MEMORANDUM

To: Surfrider Foundation

From: David Revell, PhD

Subject: Huntington Beach Desalination Review of Sea Level Rise Hazards

Figure 2. Regional Setting. Proposed site (red) and structures (orange) directly adjacent to the Huntington Beach Channel (light blue), future AES Power Station, Switch Yard, current AES Power Station and mobile home park.

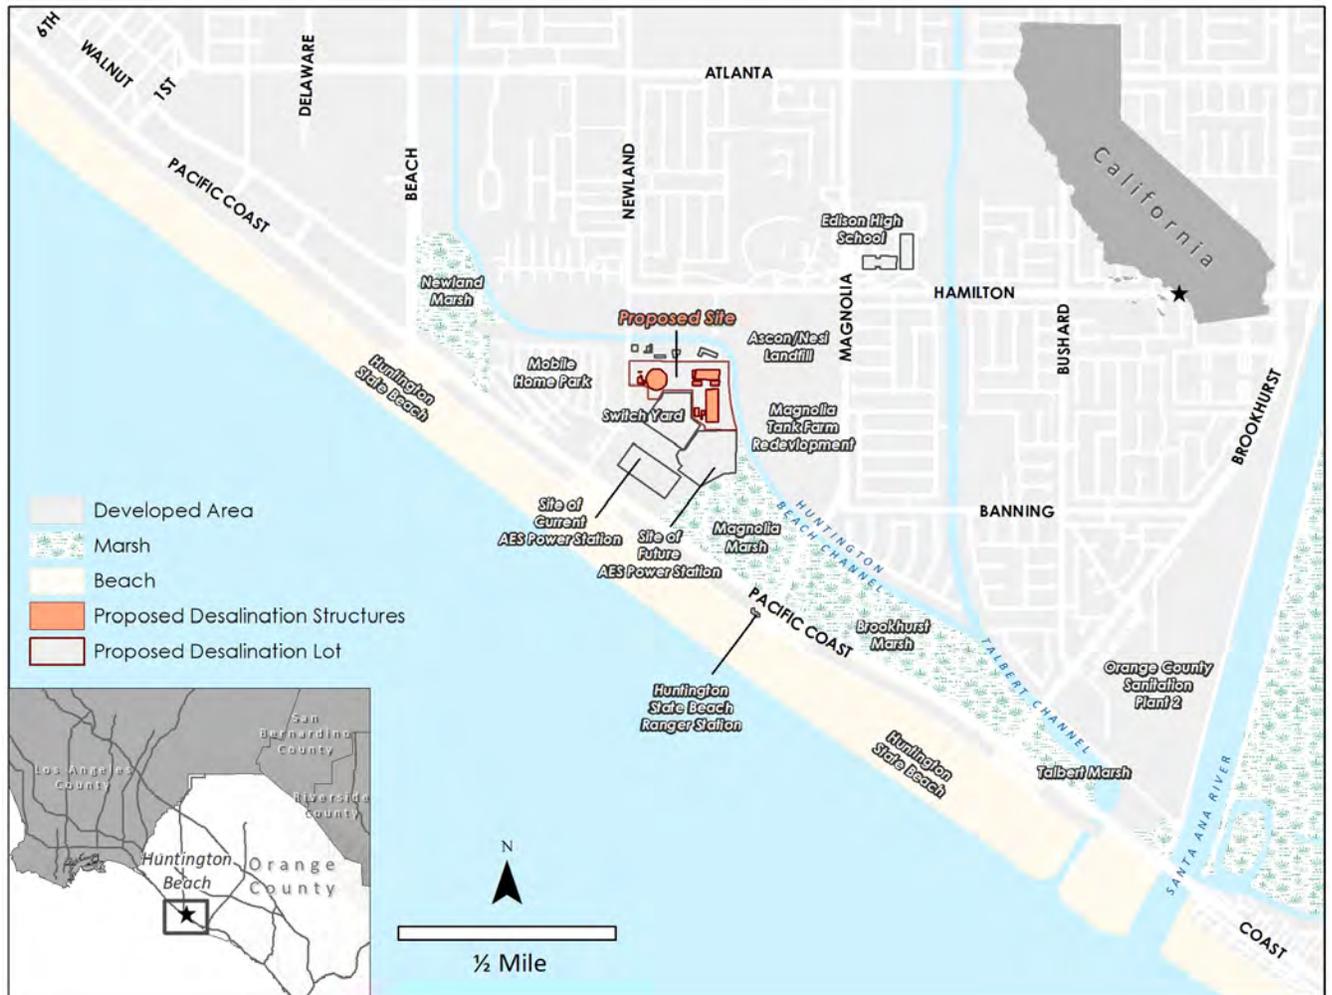
The proposed facility is located in the City of Huntington Beach, Orange County, California, in the middle of the historic Huntington Beach Wetlands (Figure 1). The site is located inland of the PCH on a parcel adjacent to and owned by AES Huntington Beach (AES HB) and is bordered by the Huntington Beach Channel to the north and east, AES HB to the south, and the AES HB switchyard to the west. Across the PCH is Huntington State Beach. The Huntington Beach Channel is hydraulically connected to the Huntington Beach wetlands and the Santa Ana River to the east, and meets the Pacific Ocean 1.4 miles to the southeast. Substantial existing residential land uses, including the recently approved redevelopment of the Magnolia Tank Farm across the channel, surround the site (Figure 2).

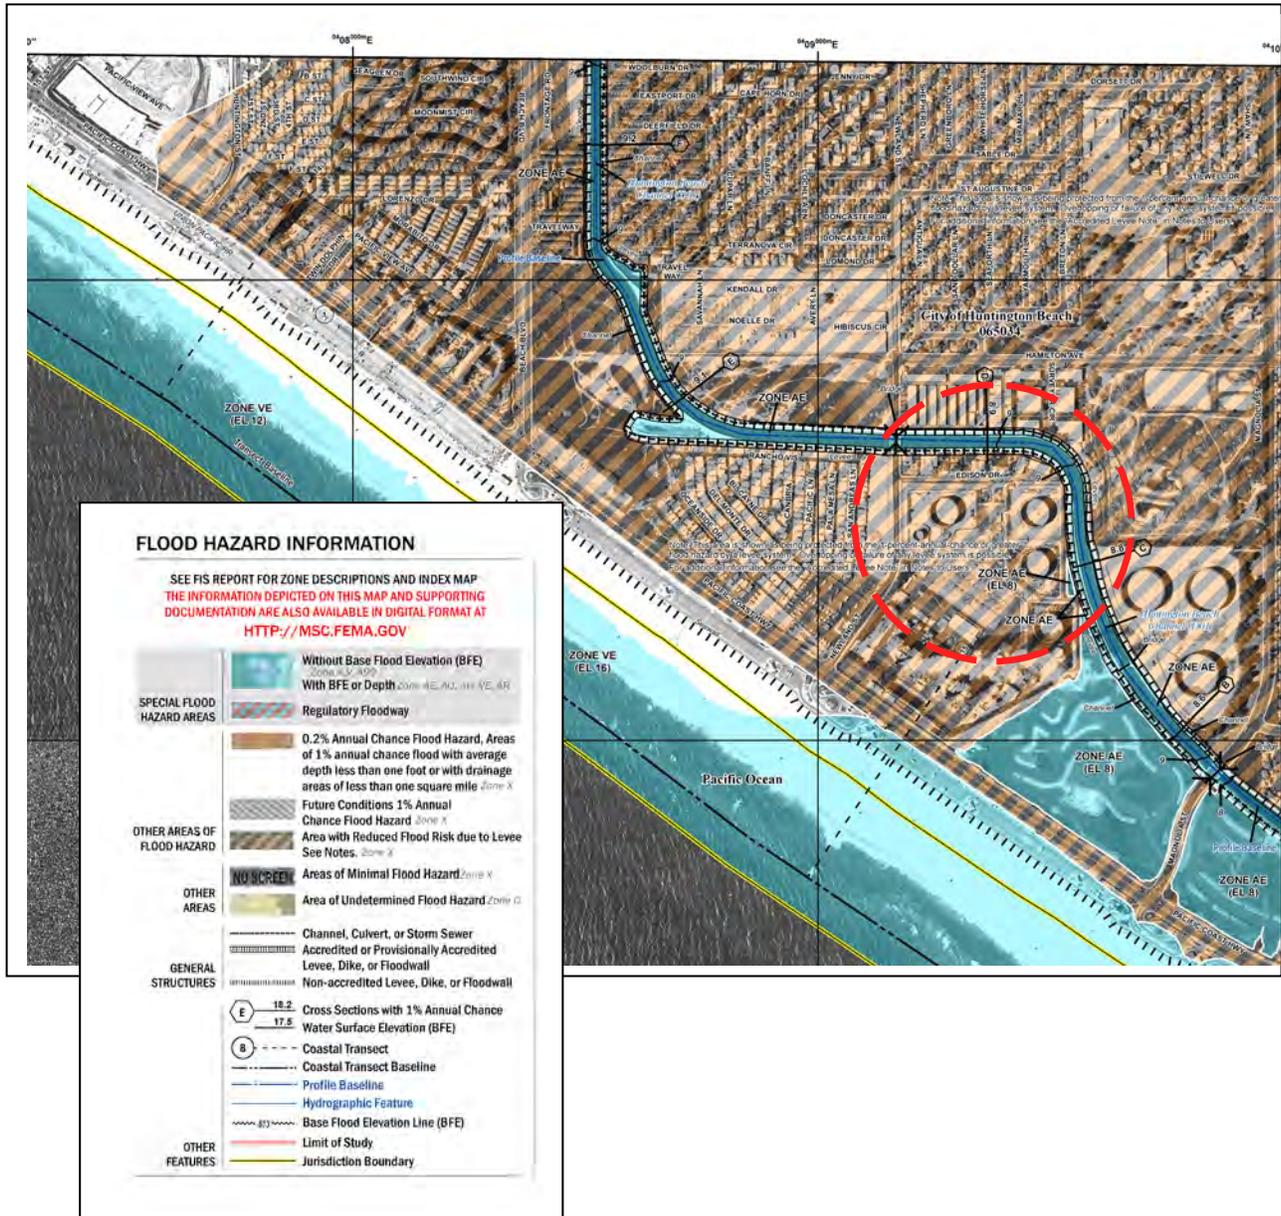
Review of available hazards show the proposed site is exposed to existing FEMA 500-year flow event fluvial hazards along the Huntington Beach Flood Control Channel (Figure 4) and the potential for tsunami inundation (Figure 3 & Figure 5). Assumptions for the tsunami analysis included no change in existing site elevations. Other existing hazards were also examined, including a FEMA 100-year flow event, a 100-year coastal wave event, coastal erosion, king tides, barrier beach flooding, and groundwater daylighting, and found not to inundate the site under current conditions. However, the barrier beach flooding and existing coastal confluence modeling could potentially affect access to the site under existing conditions.

According to the Effective FIRM (Panel 06059C0263J effective 12/3/2009, Revised via LOMR for the site 09-09-281P certified 12/15/2009), during a 100-year river flood, the flood water level in the Huntington Beach Channel is estimated to reach +9 feet NAVD (FEMA, 2009). This corresponds to data from the adjacent Huntington Beach wetlands that show a 100-year flood elevation of between 9 and 10.2 feet NAVD (M&N, 2014). The existing 500-year flood hazard shows inundation at the site and is identified as being in “Zone X” with flood depths of less than 1 foot. Flood protection at the site is influenced by tides, as flood waters are released more slowly during high tide and flow into the flood control channel and surrounding wetlands. It can be anticipated that flood extents and depths on this tidally influenced channel will rise in elevation with rising sea levels.

FEMA identifies the site as being located in “Zone X”, which is a designation for an area that is protected by certified flood control structures from a 100-year storm, but is within the 500-year Flood Zone. The site is also identified as being within the Prado Dam Failure Inundation Zone, a zone established by the City of Huntington Beach (Michael Baker International, 2017)¹⁶. Maximum water levels at the site for that scenario are estimated to be between 10 to 15 feet (CCC W19a 20a, 2013)¹⁷.

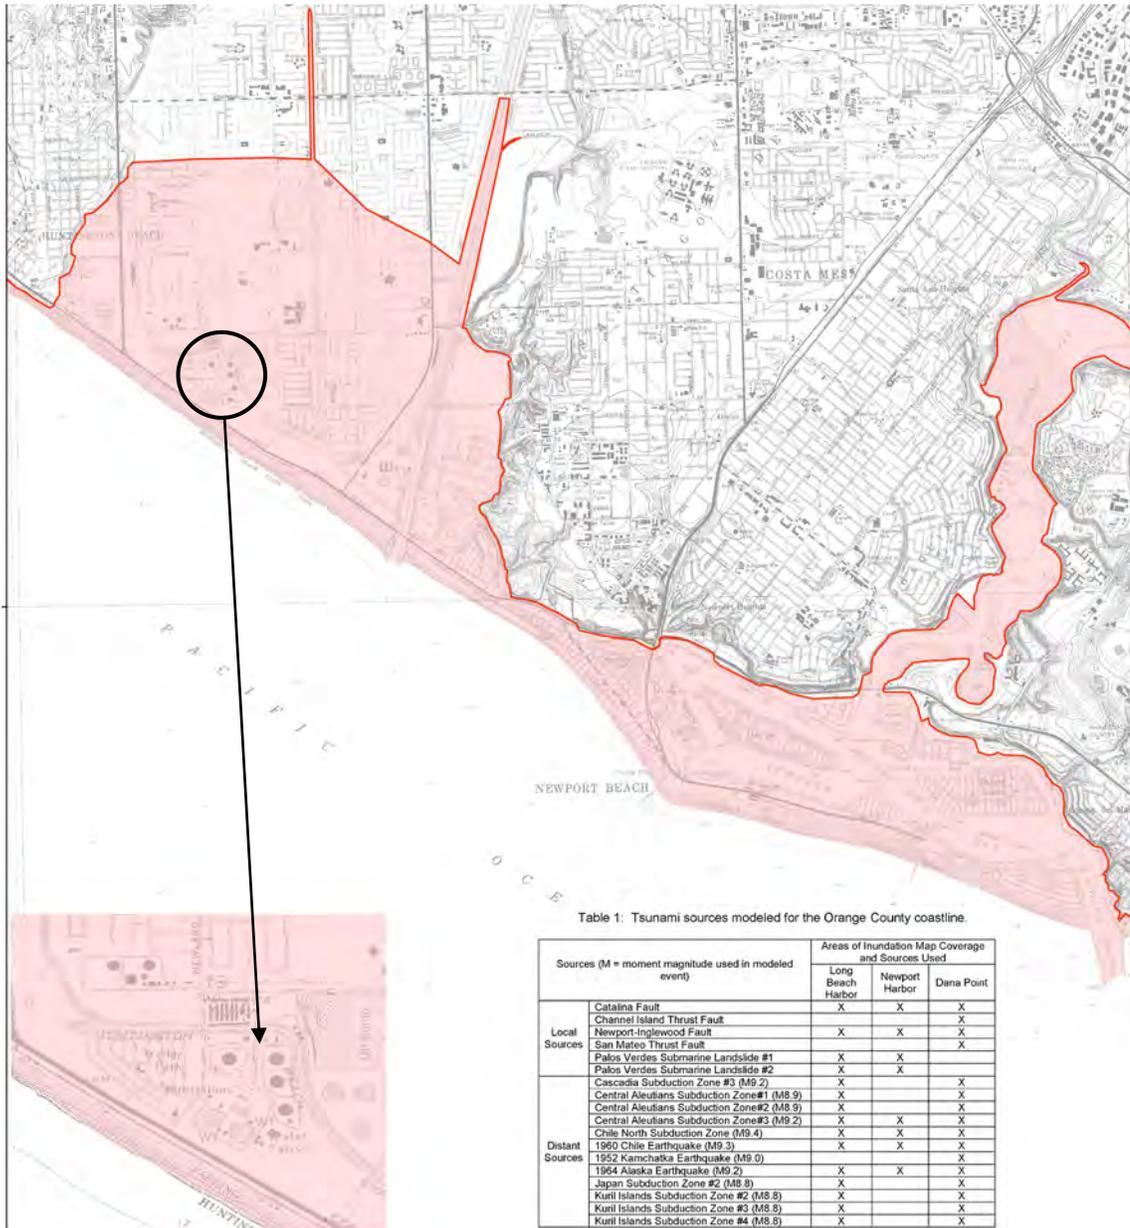
The proposed site is situated well within the 2009 California Geological Survey (CGS) Tsunami Hazard Zone (Figure 5) which extends two miles inland from shore, and within the City’s designated Tsunami Runup Zone, which extends about one mile inland from the shore. The original interpretation by Geosyntec estimated an expected worst case wave run up elevation of 10 feet MSL (Tetra Tech, 2016). Estimating expected tsunami runup elevations at the site is significantly more difficult than modeling other flooding events, as it relies on many onshore and offshore characteristics, and the severity of tsunamis is heavily influenced by propagation direction and potential current amplification from nearby stream channels. CCC staff, in consultation with staff from CGS and CalEMA, interpreted the tsunami run up elevation with available topography, and identified that the AES HB site had a current projected tsunami wave runup elevation of approximately 11 feet MSL or 13.6 feet NAVD88 (CCC W19a 20a, 2013)¹⁸. No comprehensive study considering both kinetic energy, wave height currents, return flow scour velocities and their forces on proposed structures and “garden walls” was conducted. But based on the analyses that were conducted, the project site is within the Tsunami Wave Runup Zone and would remain inside the hazard zone regardless of the proposed facility grading plan.

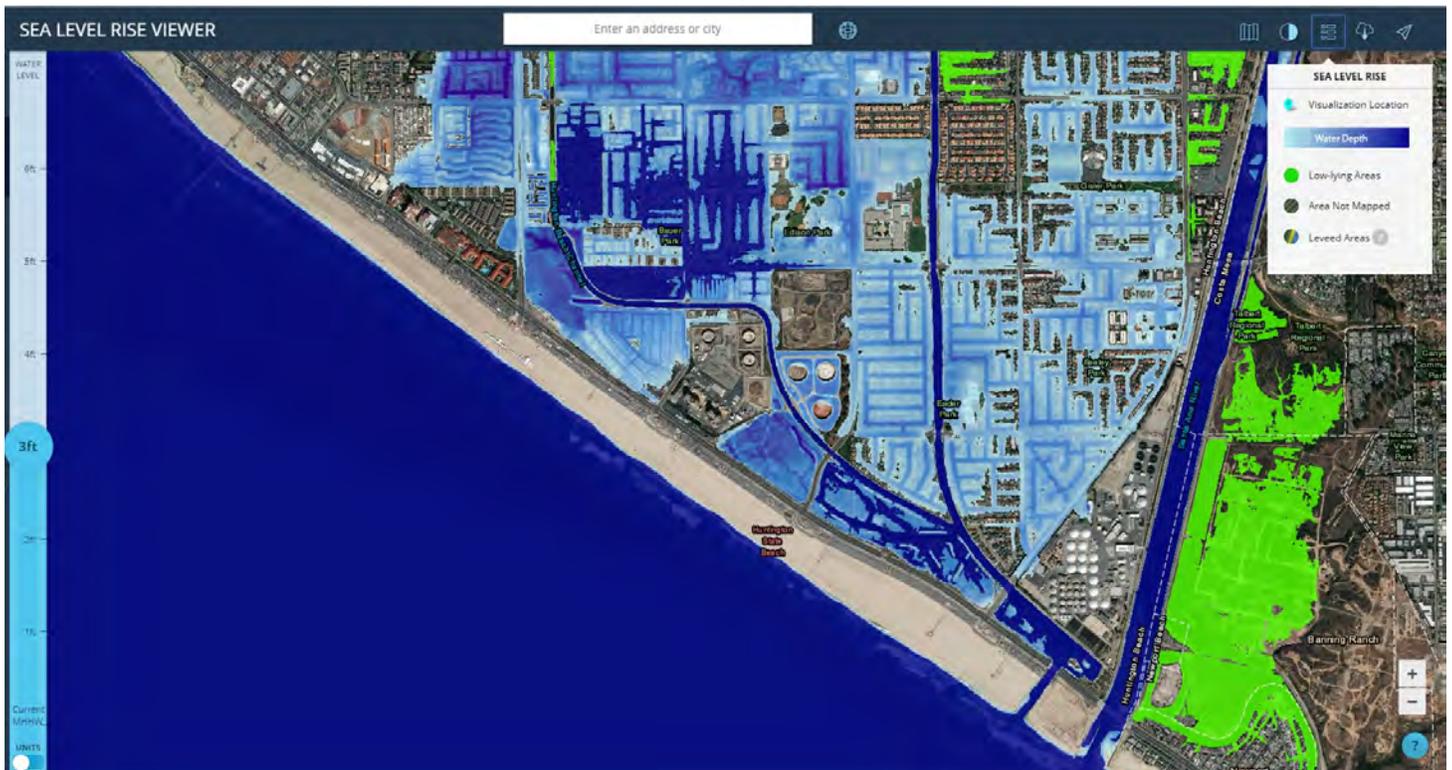
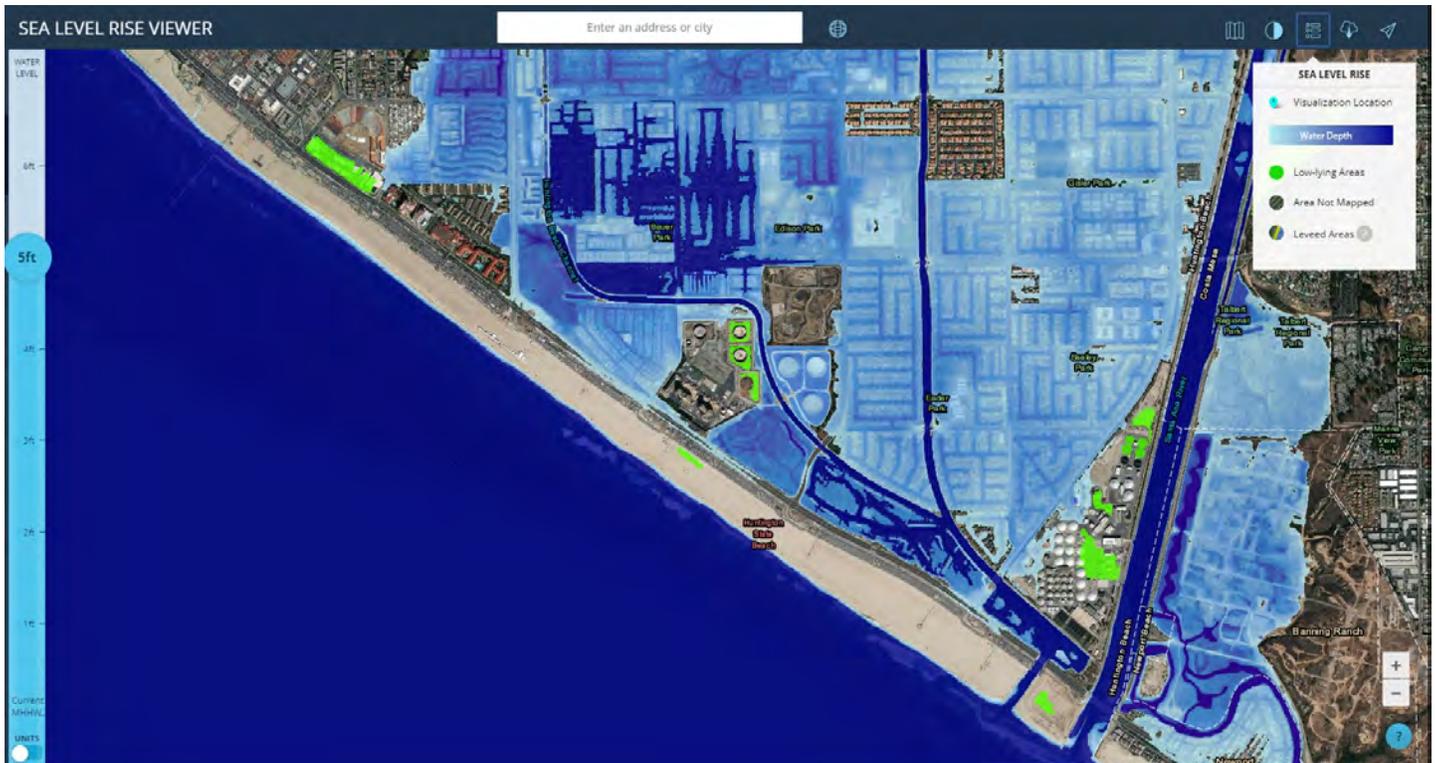
The NOAA SLR viewer maps a MHHW (5.29' NAVD) flood extent with up to 5' feet of SLR on the existing topography, which could occur as early as 2070 under the H++ scenario (figure 6(B)). The map shows that under existing conditions and 3 feet of SLR, the site is relatively safe from flooding (figure 6(A)). With 5 feet of SLR, the three eastern most oil storage tank sites could be inundated if hydraulically connected, and with 6' of sea level rise, all of the tanks could be flooded. However, a current king tide is nearly 2 feet higher than MHHW, meaning that under existing topography, Figure 6B flooding could occur a few times a year with only 3 feet of sea level rise.

Results of the tidal inundation mapping show relative depths in the shades of blue which don't appear to affect the site. Shades of green are low-lying areas where, if hydraulic connections exist (e.g. via a culvert or gap in containment berms) beyond the resolution of the model elevation grid, those areas could also be flooded. The green could also indicate areas that could be flooded through daylighting groundwater if the duration of those tide waters is sufficient. An in-depth analysis on daylighting is provided in a following section.

Figure 7 (A). Wave run up flooding from a 100-year wave event and 5 feet of sea level rise. **(B).** Wave run up flooding from a 100-year wave event and 6.5 feet of sea level rise. Site identified in red circle.

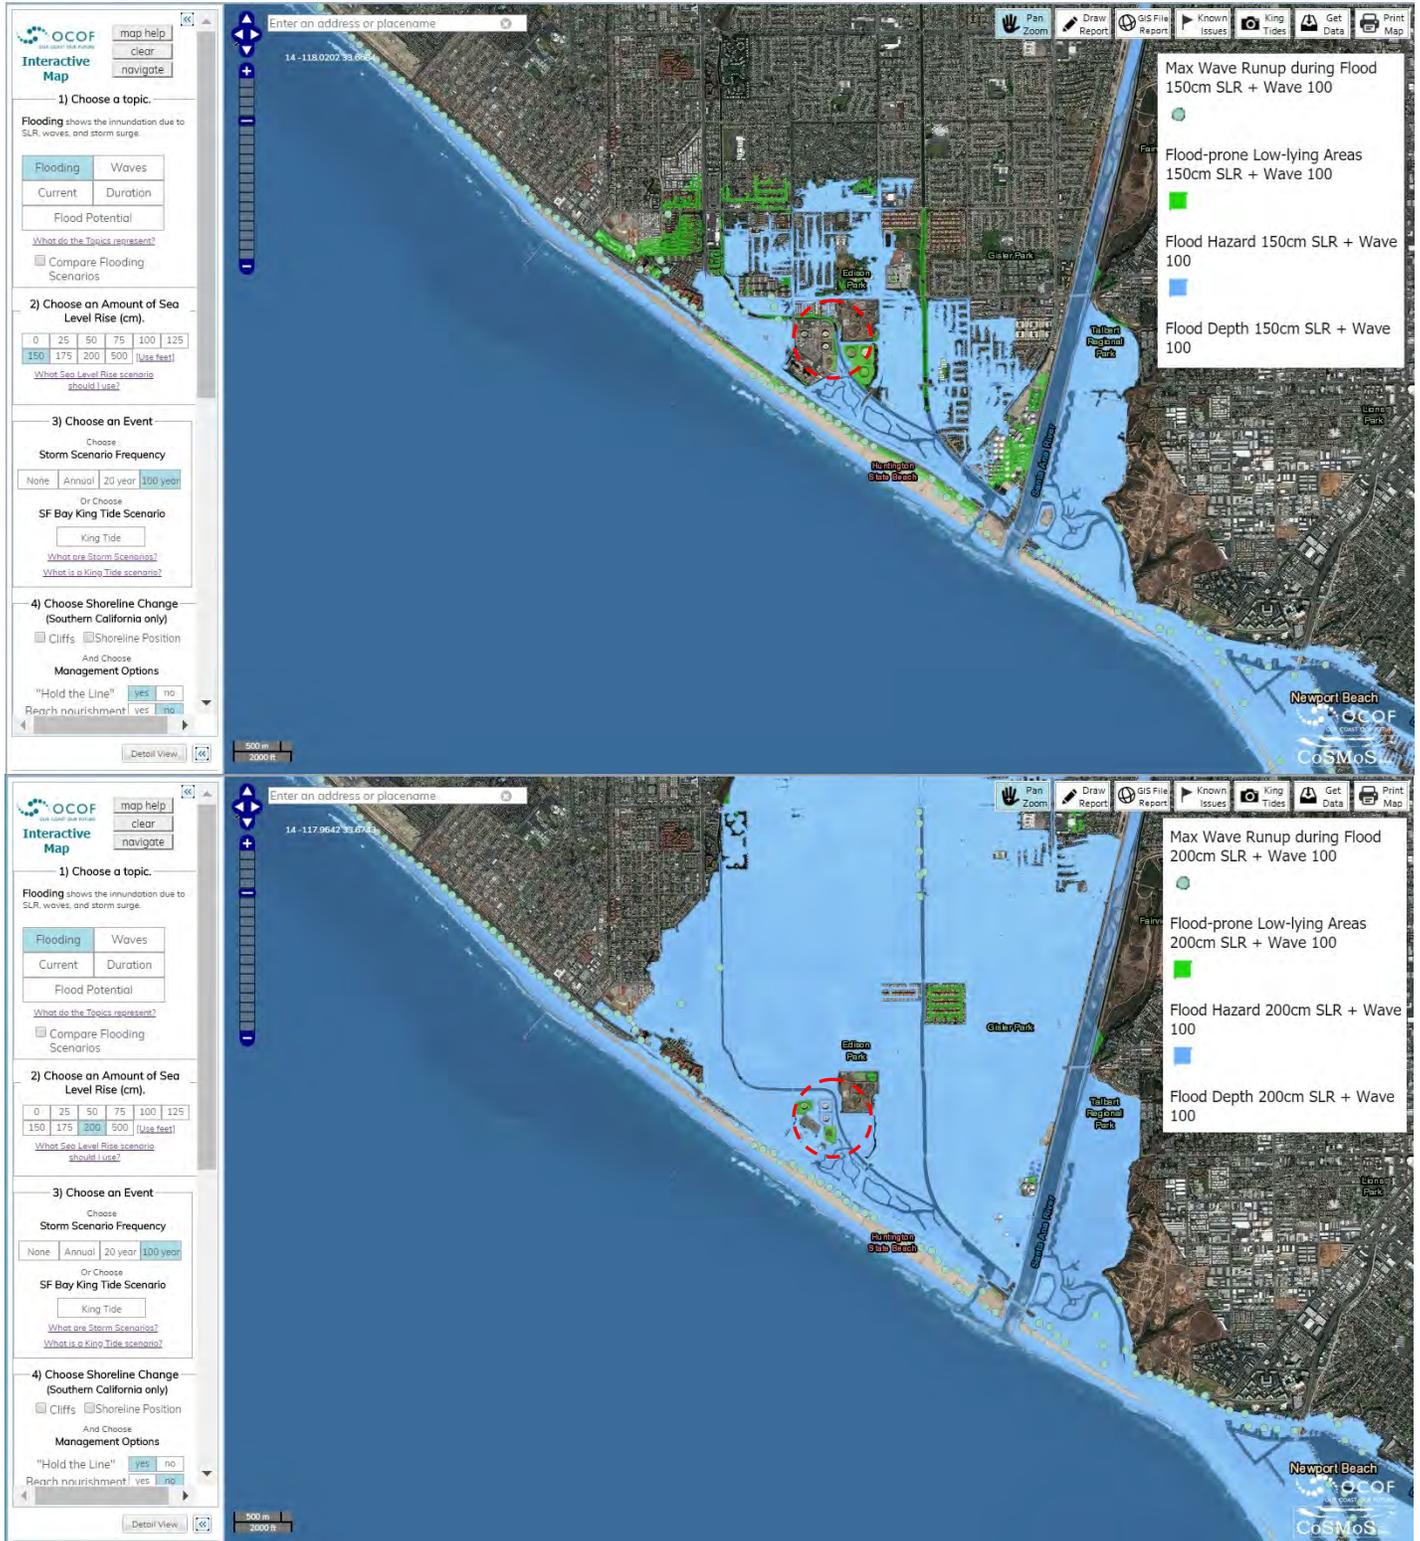
Results of the CoSMoS 3.0 model do not show much sustained coastal wave flooding to the site with up to ~5 feet of sea level rise, even with current low elevations. However, maximum wave run up does show that waves could run up to inland areas beyond the proposed site, potentially impacting access to the proposed facility (Figure 7A). With 6.5 feet of sea level rise, the site could be expected to be impacted by sustained flooding across most of the site, and maximum wave run up extents could extend over 2 miles inland. Flood depths at the proposed site for existing topography show potential flood depths of 0.8 feet to 3.4 feet with ~5 feet of sea level rise and 1.5 to 4.1 feet with ~6.5 feet of sea level rise. The range in flood depths are based on model uncertainties.

There are some apparent issues with the CoSMoS 3.0 results. First, the model does not account for flood control channels on Talbert Channel or Huntington Beach Channel, nor does it account for the existing hydraulic connection across the beach under the bridge on the PCH. It is also not entirely clear why wave run up at one transect would not get the beach wet during a 100-year wave event and 6.5 feet of sea level rise, yet on the adjacent transect wave run up could travel 2 miles inland. The variability in these model results do call into question the vulnerability to wave run up at the actual site.
